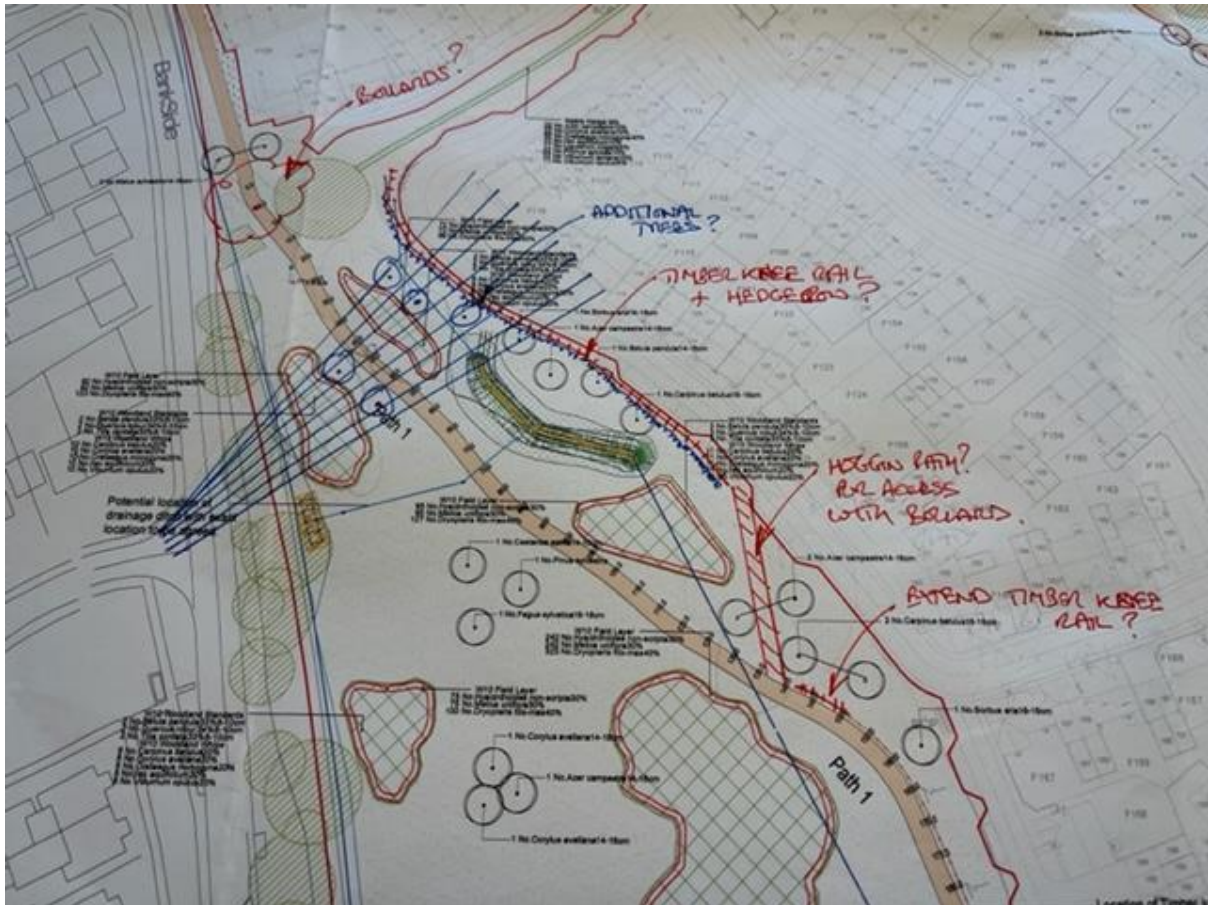
Whilst there are some potential benefits of the path being relocated further away from Longdon Crescent the revised route of the path also makes access to the community park by residents of the crescent considerably more difficult. In direct dialogue with Taylor Wimpey, we had requested the addition of a short Hoggin Path, in the approximate location shown on the image below, to reconnect the crescent to the revised path route but this has been rejected by Taylor Wimpey.

In addition, due to roadway kerb heights in the crescent being no more than 30-40mm providing no protection against vehicles for access or parking from the crescent, we requested the installation of a knee rail timber fence similar to that installed in numerous other areas of the park. This request has also been rejected by Taylor Wimpey.
